Ercoupe BULLETIN

SUBJECT: Filter Assembly—Modification of

FIG. 1

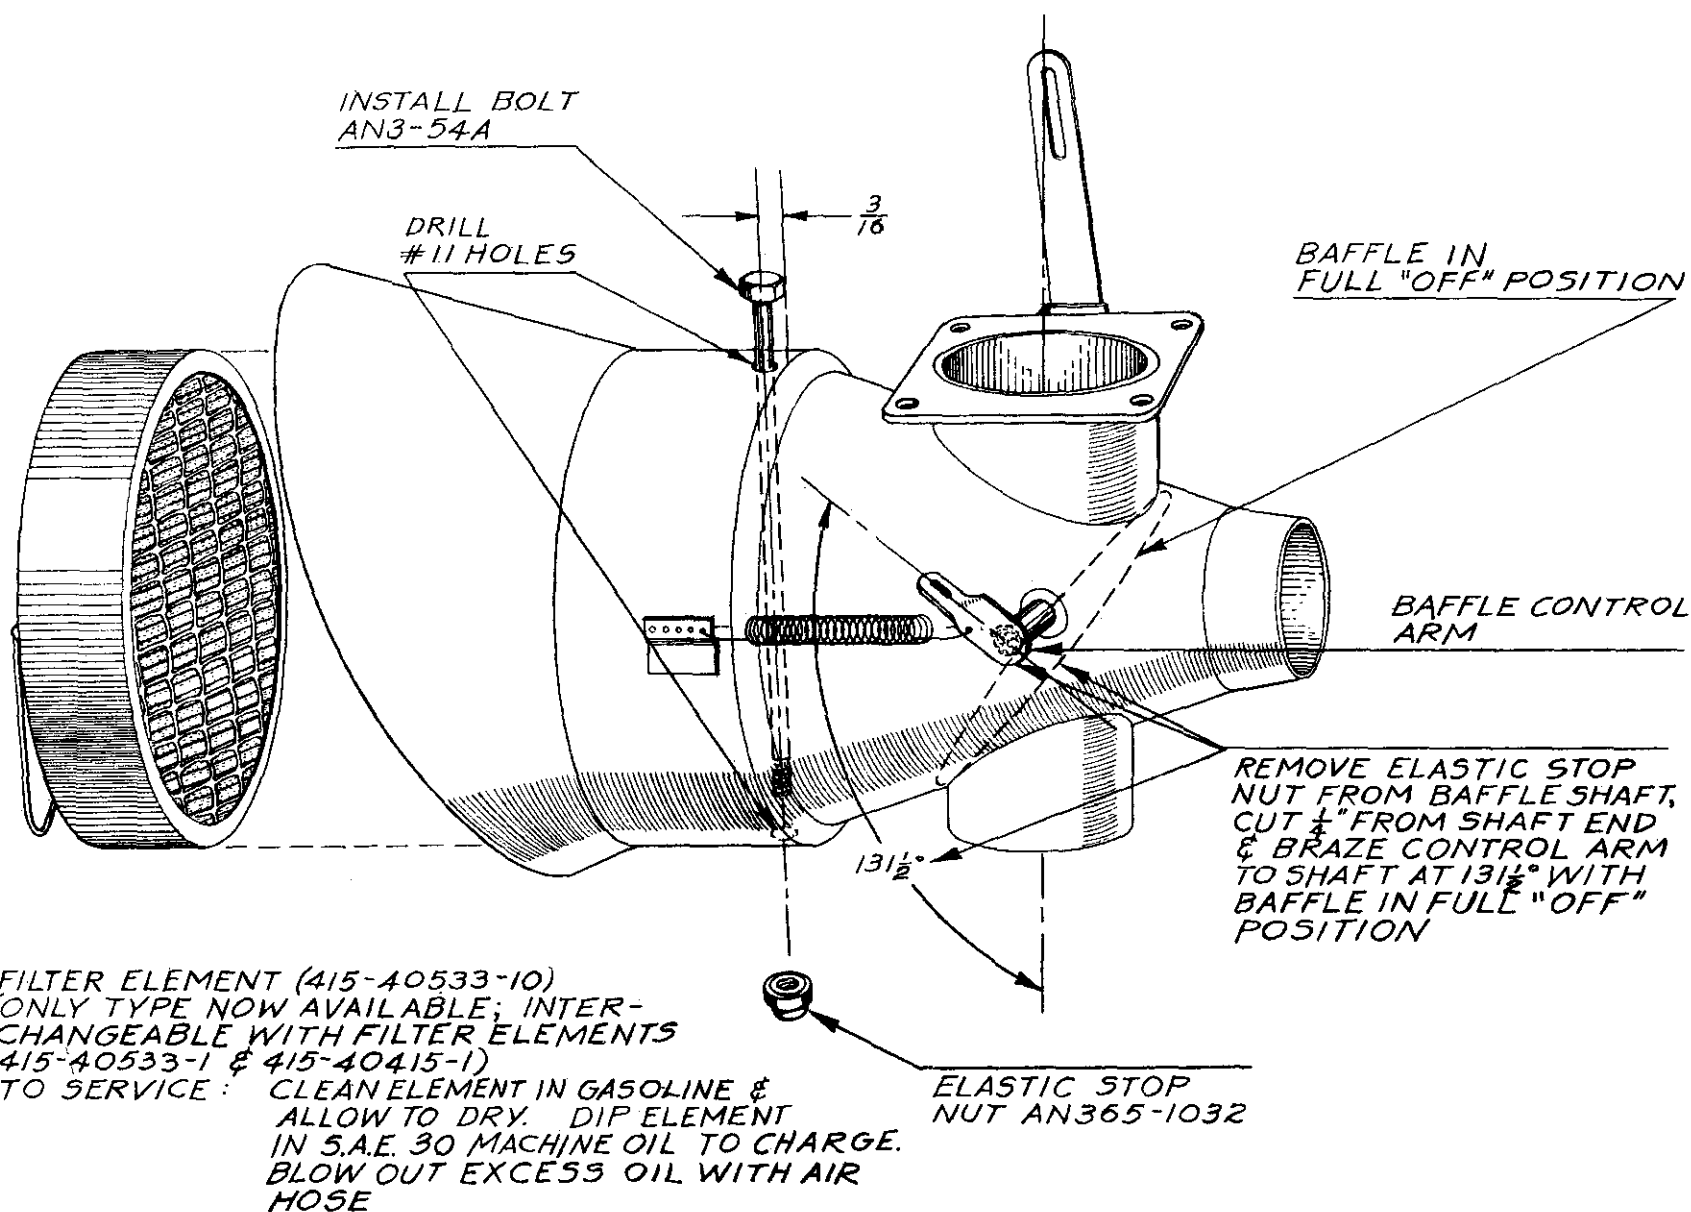
Interference of the baffle with the filter element within the carburetor filter assembly, resulting in a jamming of the throttle and a lack of proper carburetor heat control, has been reported. This is caused by the filter element slipping back into the travel arc of the baffle, interfering with throttle operation. It may be followed by the baffle control arm slipping on the baffle shaft. Effective Serial numbers 113 to 2749, inclusive, a wire type filter element was installed. A new type non-metallic filter element (415-40533-10), which is somewhat thinner, has been installed in Ercoupes, Serial numbers 2750 and subsequent. The filter assembly using the new type filter element has recently been modified with three dimples to hold this thinner element from slipping too deep into the filter assembly element recess. It is recommended that all the filter assemblies with old type elements (Serial Nos. 113 to 2749, inclusive) and the filter assemblies, with new type elements (Serial Nos. 2750 and subsequent), without the three retaining dimples, be modified. The filter baffle control arm was attached to the baffle shaft with an elastic stop nut on a few Ercoupes (Serial Nos. 1600 to 4400). This should be changed to a welded attachment on these airplanes at time of this modification. It is recommended that this Bulletin be complied with as soon as possible but no later than the next 25 hour check.

- a. Install bolt (AN3-54A) as follows:
(Ref. Page 2, Fig. 1) (Ser. Nos. 113 to 2748, inclusive).
 - (1) Drill two No. 11 holes through the centerline of the filter assembly in the vertical plane, $\frac{3}{16}$ " forward of the element retainer flange. On the filter assemblies that are formed with a flange in this plane, the holes should be located about 10° off the vertical to clear the flange.
 - (2) Install bolt (AN3-54A), with hexagon head at top of filter and secure with elastic stop nut (AN365-1032).
 - (3) Check travel arc of baffle for interference with bolt. If the baffle touches bolt, file forward end of baffle until adequate clearance is obtained.
 - (4) Insert filter element, and secure with original clamp, screw and elastic stop nut. The stop nut may be replaced by an anchor nut which will simplify removal of the filter element when filter is in place.

b. Modify Baffle Control Arm (415-40530) where applicable as follows:

(Ref. Page 2, Fig. 1). Approx. Serial Nos. 1600 to 4400).

- (1) Remove baffle control arm after unscrewing elastic stop nut from baffle shaft.
- (2) Cut $\frac{1}{4}$ " off the threaded end of baffle shaft.
- (3) Braze baffle control arm to shaft at 90° to baffle. With the baffle in the full off position, the arm is $131\frac{1}{2}^\circ$ to the vertical centerline. (See illustration)

- a. Reinstall filter assembly in reverse order of Paragraph 1. The brass wire guide used on the hot air manual control should be clear by $\frac{1}{32}$ " when the throttle is full open. The filter baffle arm on right side of filter assembly must have an over-travel clearance of $\frac{1}{32}$ " when the throttle is in the full idle position. This clearance is adjusted by relocating the carburetor throttle arm.

INSTALL BOLT
AN3-54A

DRILL
#11 HOLES

REMOVE ELASTIC STOP
NUT FROM BAFFLE SHAFT,
CUT $\frac{1}{4}$ " FROM SHAFT END
& BRAZE CONTROL ARM
TO SHAFT AT $131\frac{1}{2}^\circ$ WITH
BAFFLE IN FULL "OFF"
POSITION
